Town of Clayton
Technical Review Committee Meeting - FINAL Agenda
Wednesday, September 26, 2018 @ 9:00 AM
GS 223 - Clayton Town Hall

PRELIMINARY SUBDIVISION PLAN FOR CREECH TRACT DEVELOPMENT TOWN OF CLAYTON - JOHNSTON COUNTY, NC

FROM: Planning
CONTACT: Haley Hogg, Planner, hhogg@townofclaytonnc.org
DATE: May 16, 2018
PROJECT NAME
& NUMBER: 2018-90-SD Creech Tract Major Subdivision
SUBJECT: 1st Review Comments

Job: 16048	Date: 8/29/18	Revision:	
File: 16048-Prelim_Sub4_REV	Drawn: WJB	Sheet: 1 OF 22

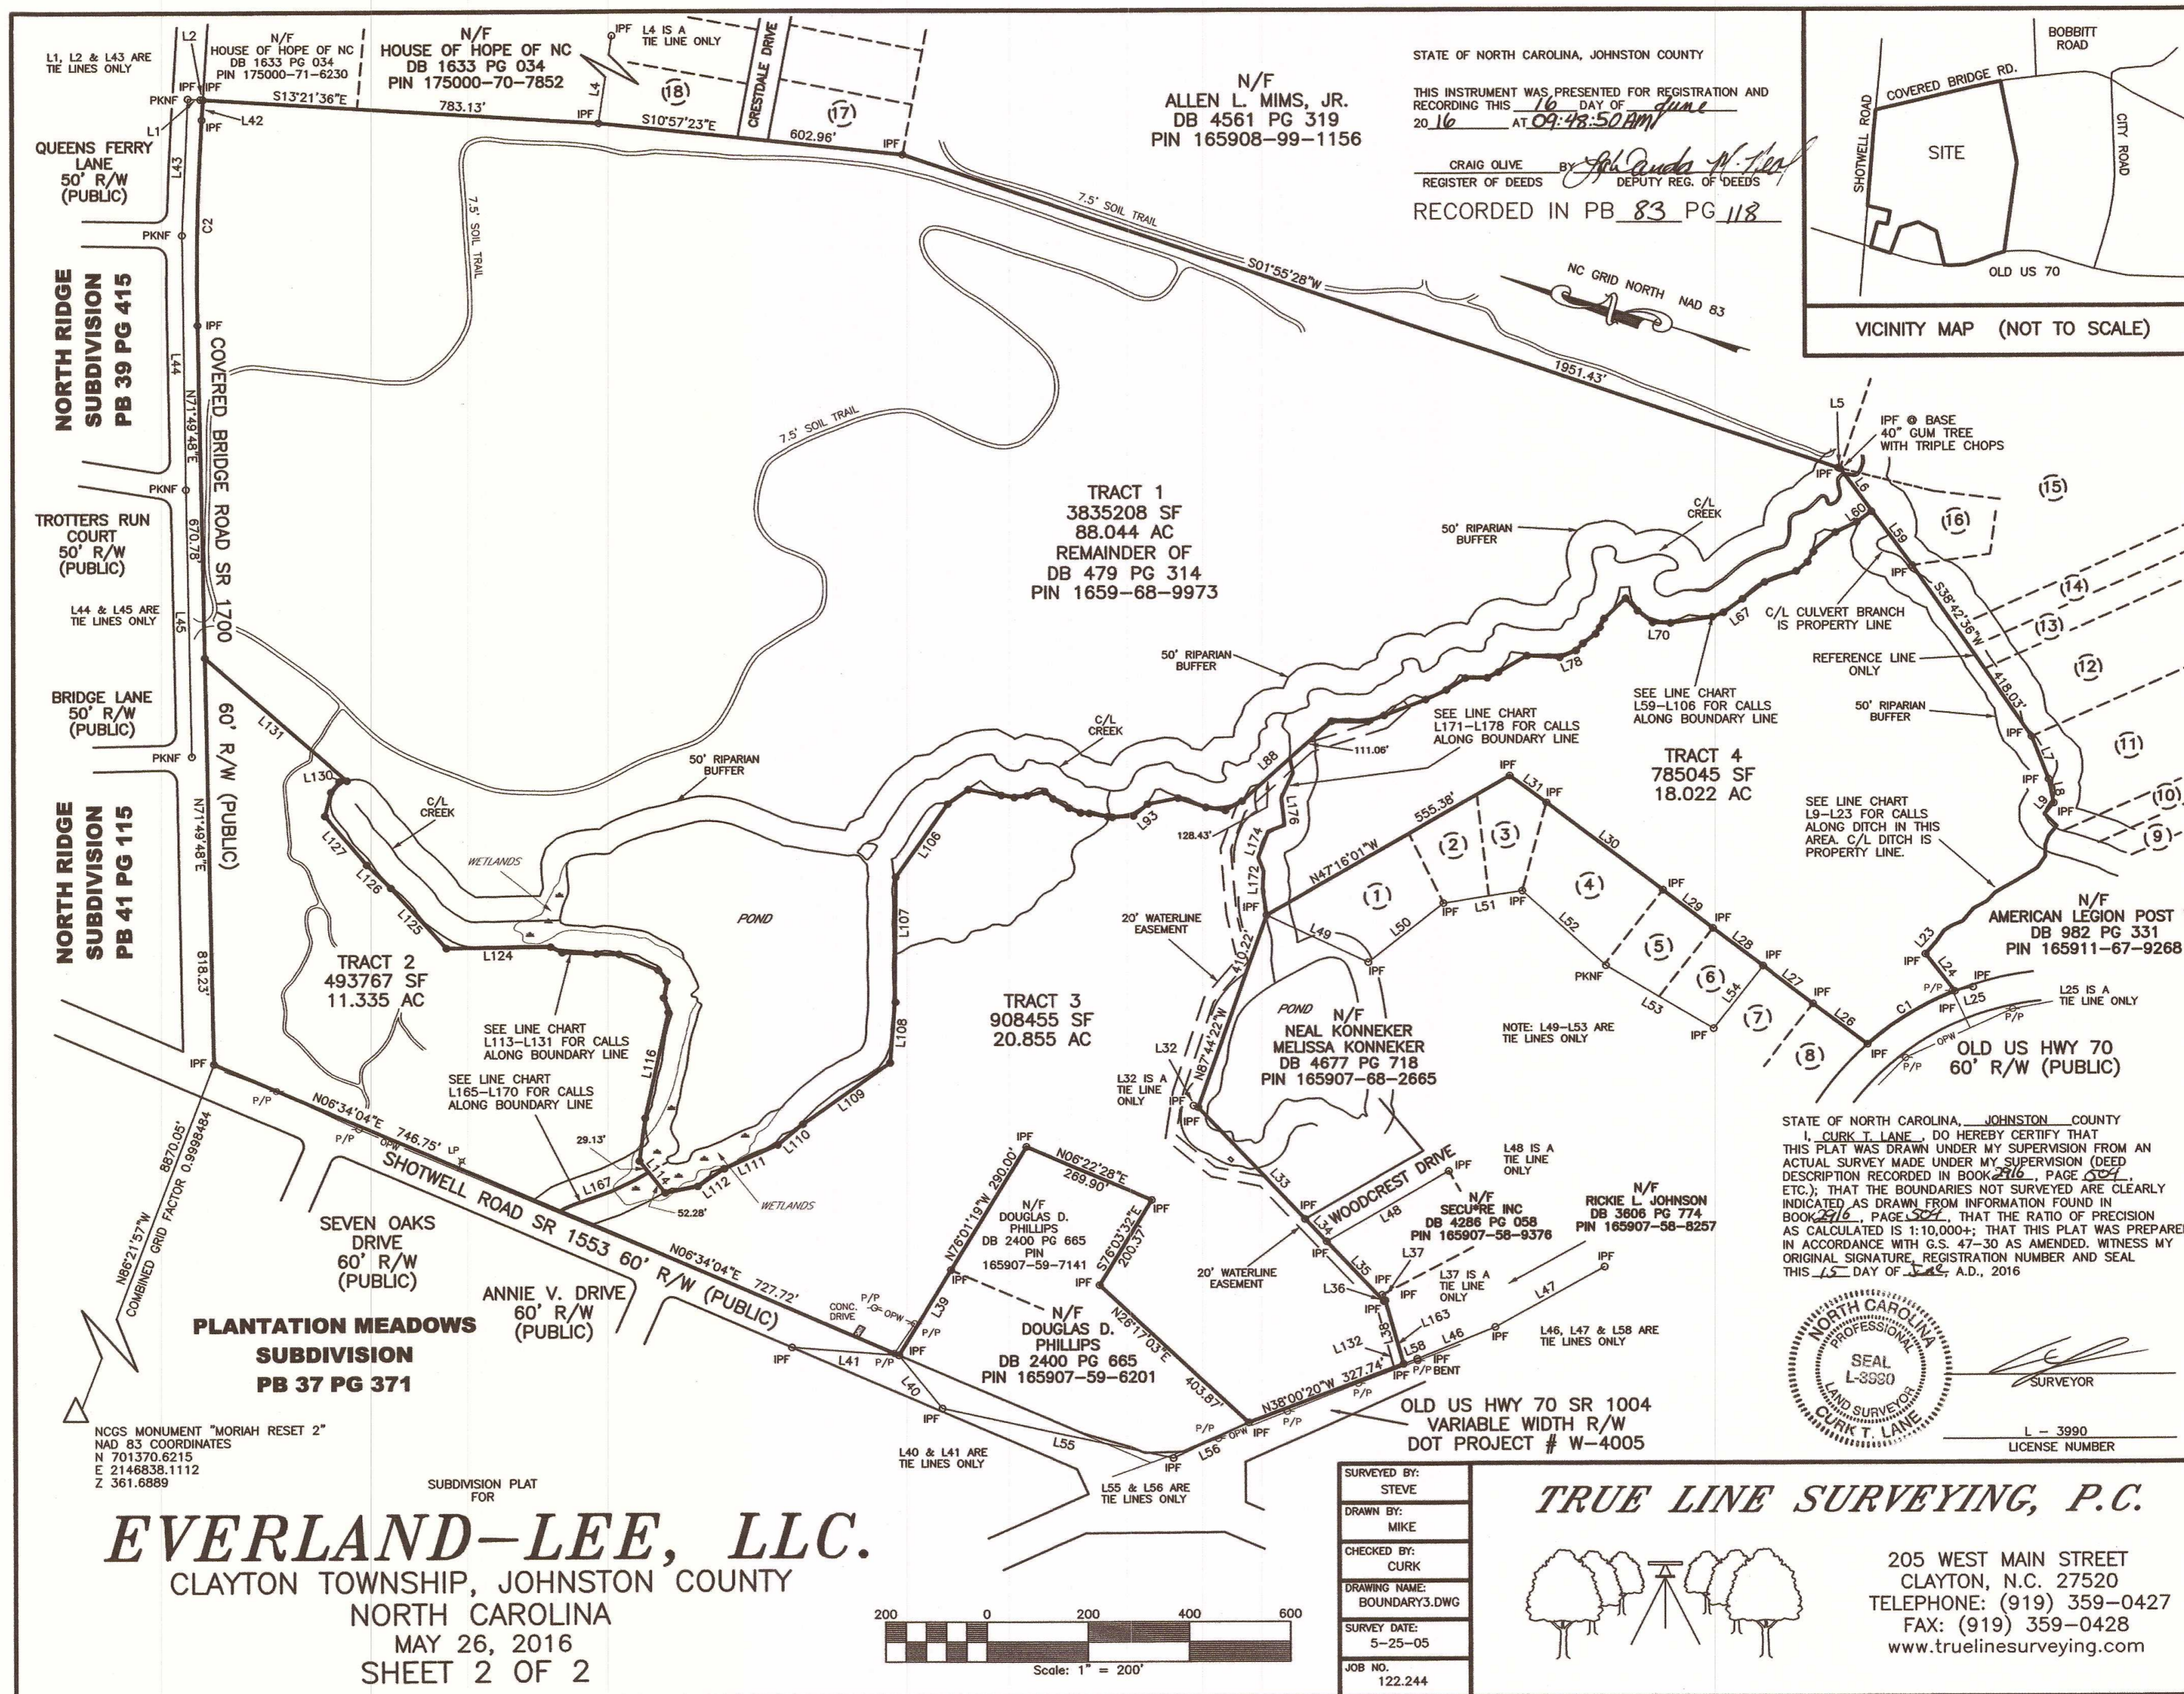
1. Please record the project number on the cover sheet.
Reply : The project number has been added to the upper right hand corner of the cover sheet.
2. Please outline the subject properties on the vicinity map; as it is currently submitted it is unclear exactly which properties are included within this submittal.

1. Add firm license number to cover sheet
Reply : Engineer's license number is shown on Cover Sheet. See Sheet 1 of 22.
2. All sheets need to be signed and sealed. Name on seal is not visible. Engineers license number is not visible. (all sheets)

Dalton Engineering and Associates, P. A.		
446 East Main Street P.O. Box 426 Clayton, NC 27520		(919)550-4740 Fax (919) 550-4741
Job: 16048	Date: 8/29/18	Revision:
File: 16048-Plan1a_Sub1a_REV	Drawn: WJB	Sheet: 8 OF 22

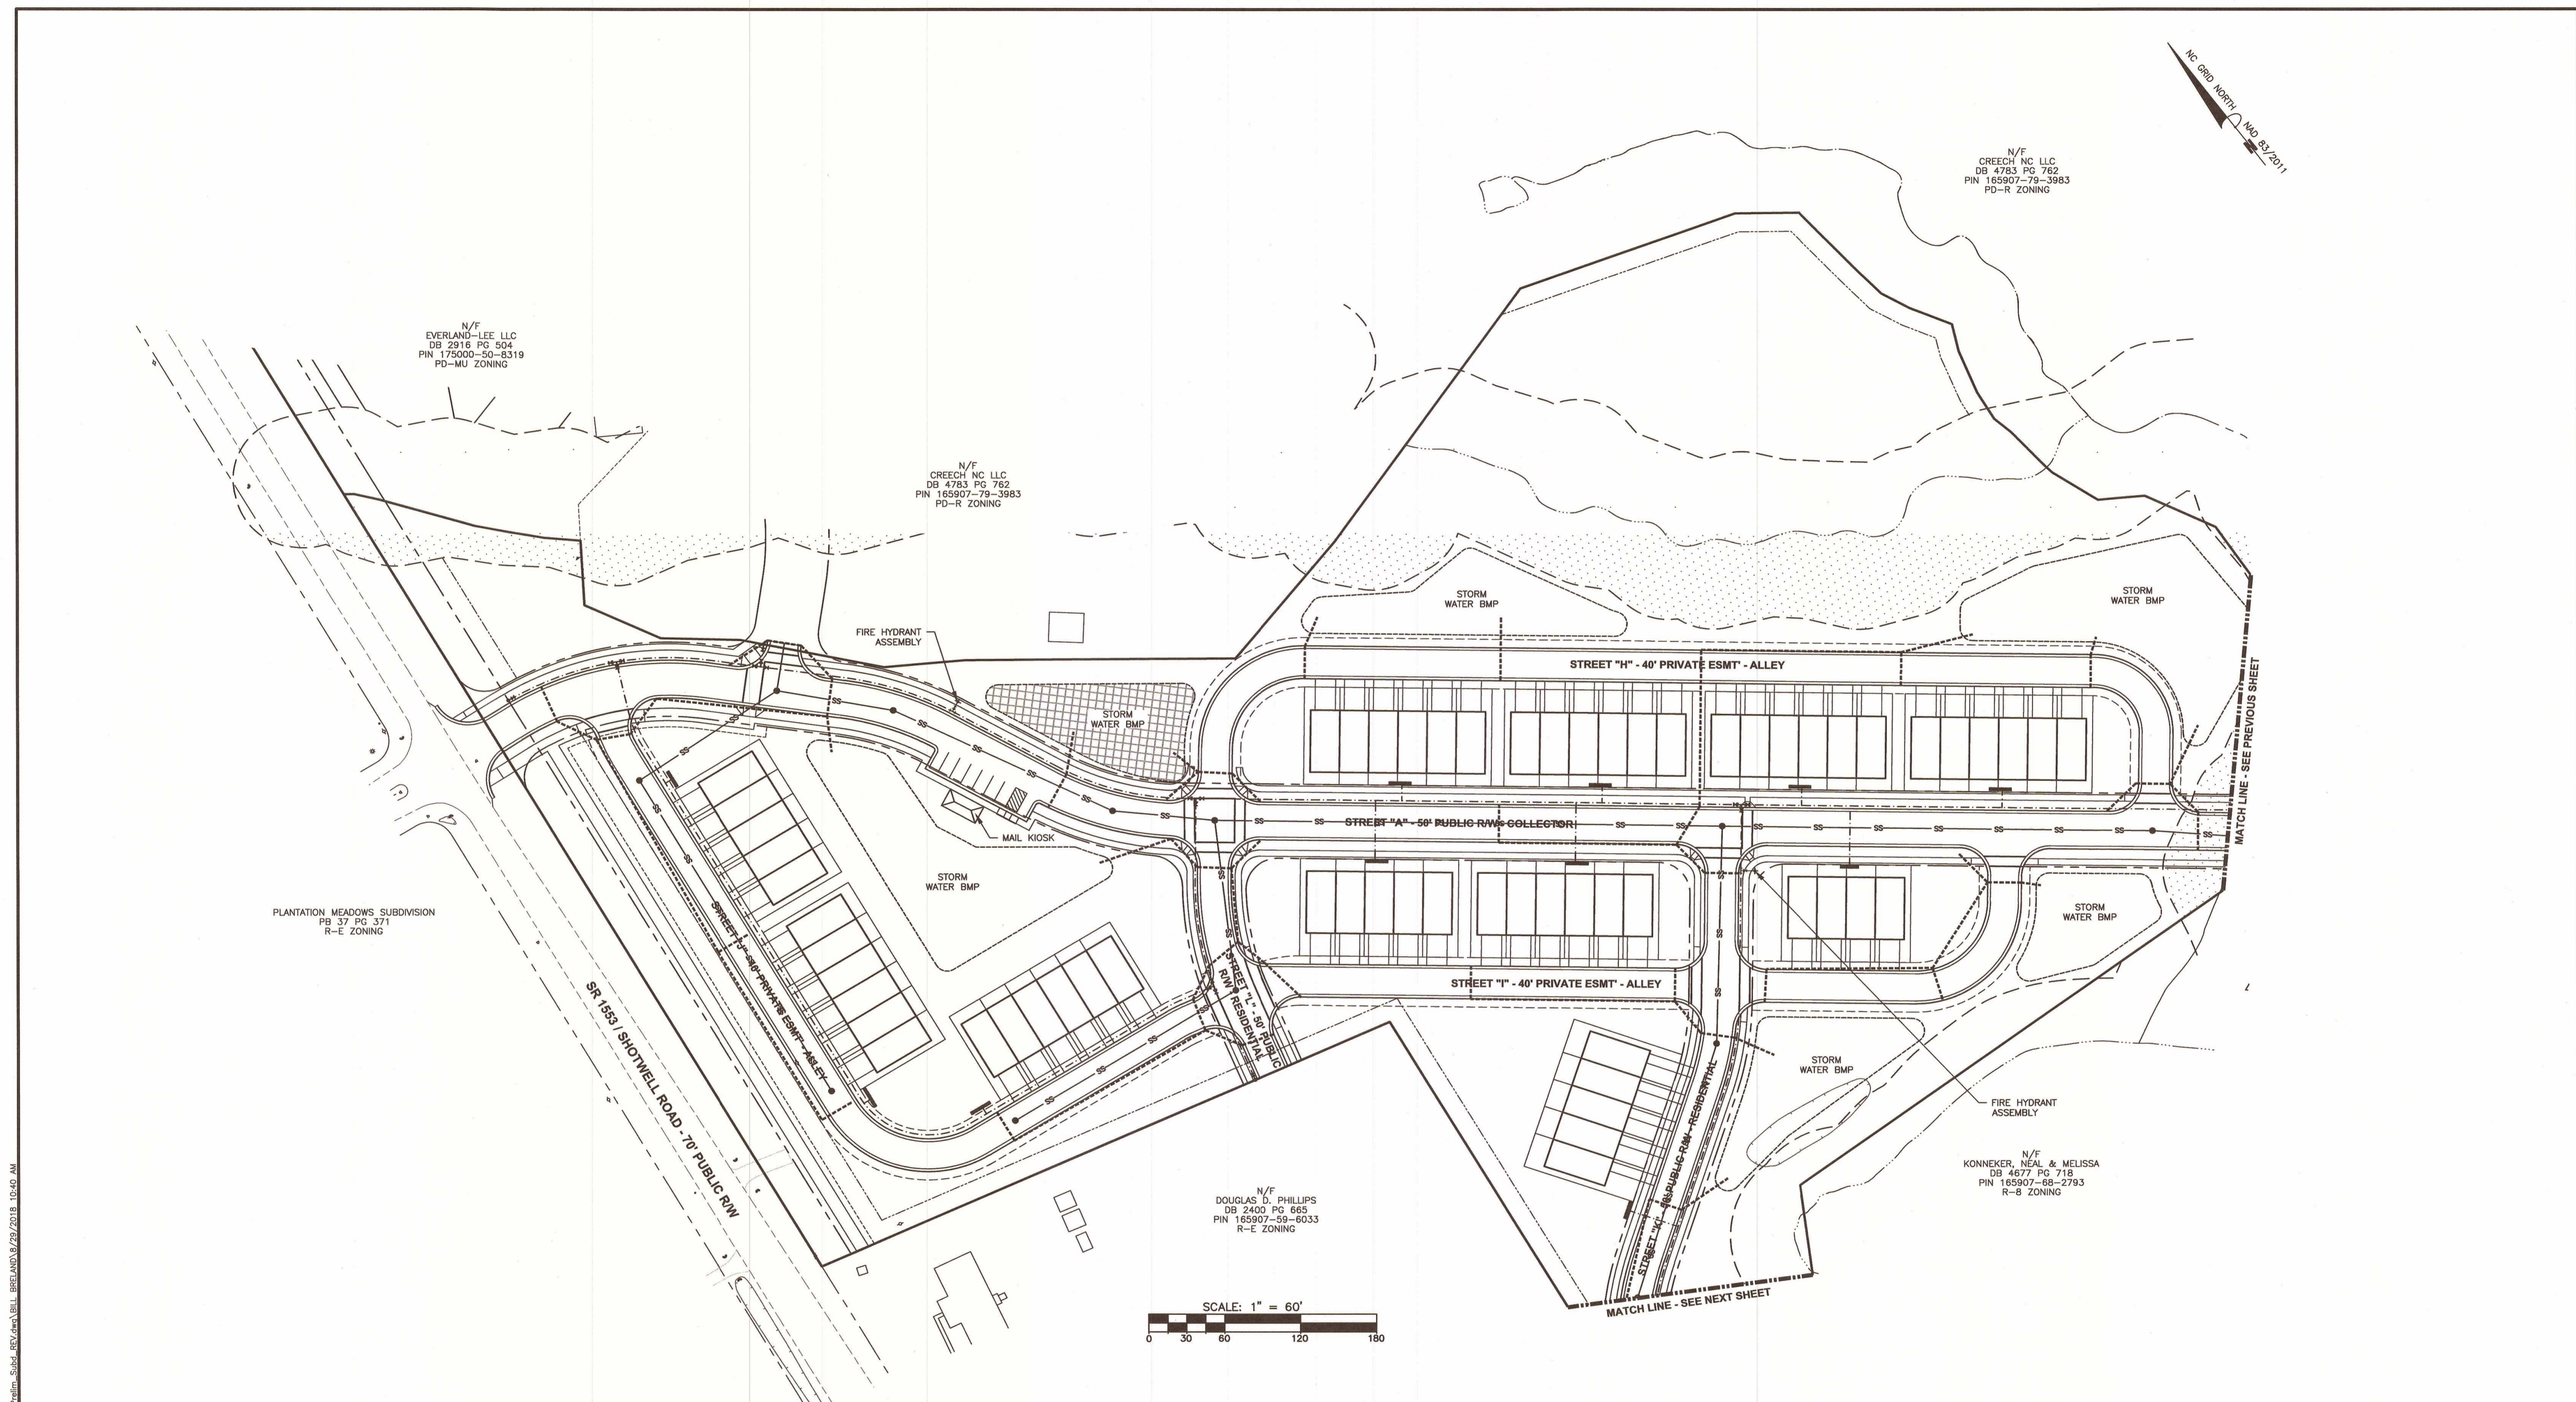
Reply : The sheet labeled "Preliminary Utility Plan – Phase One" (Sheet 8 of 22) depicts two proposed sanitary sewer manholes located within the Street 'B' right-of-way that the Town could tie into. Are Utility Construction Plans available from the Town of Clayton showing the proposed depth of the Town's future sanitary sewer outfall in this area ? If so, would the Town provide Dalton Engineering and Associates, P.A. a copy of the Construction Plans ?
